## Murphy-PFFS-SPOOL-BOM

WUSM RESEARCH BUILDING	5/14/2021		
NRB CUP			
LVLO2 SPOOLS			
SERVICE NAME			
CHWR HRC			
REF.DWG.			
DRAWING NO./TRACKING NO.	QTY.	SHT/NO	REV
210140-A-UPL2-26-7	1	1 of 1	0

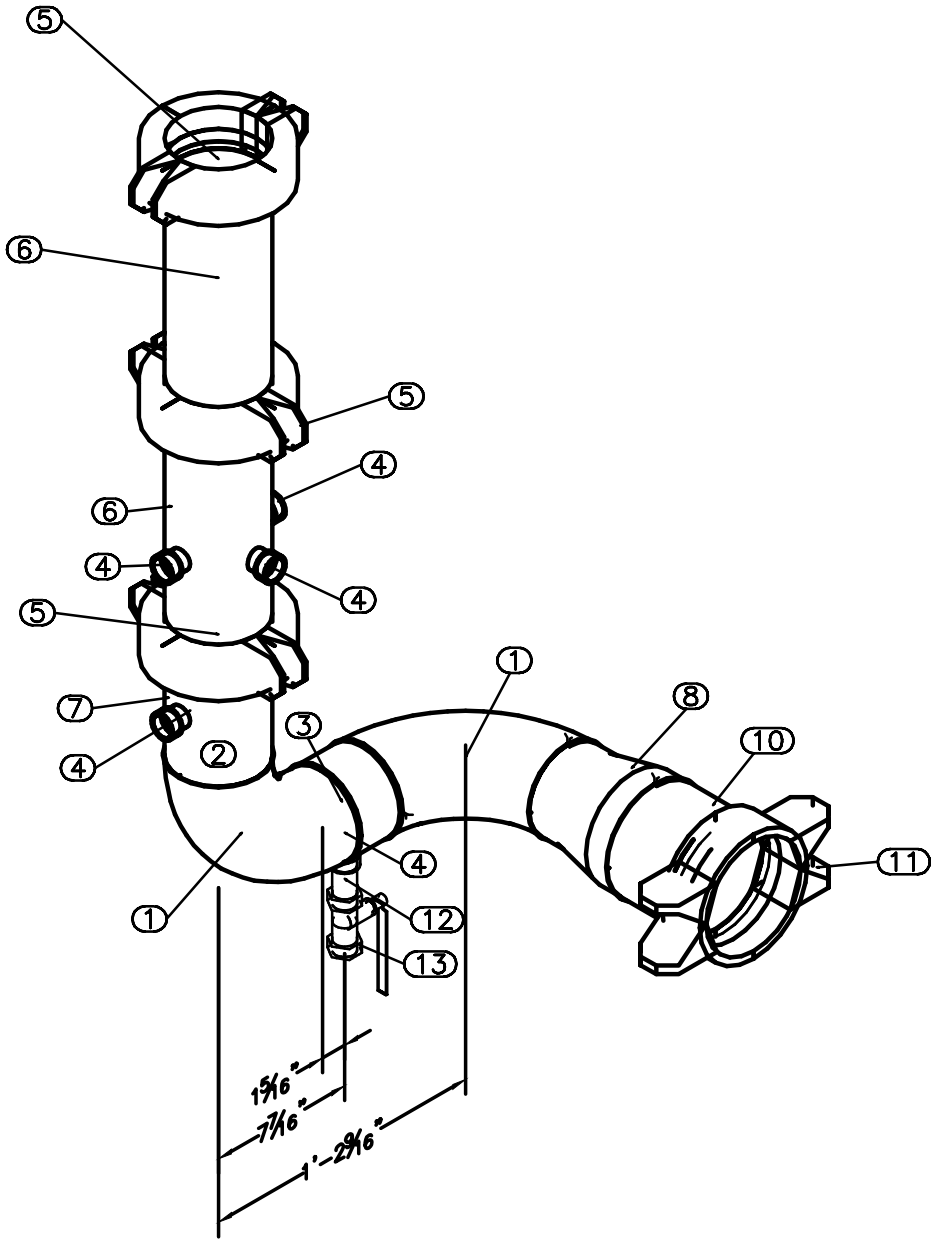
should be an Apollo  
77C-140 Series  
Ball valve
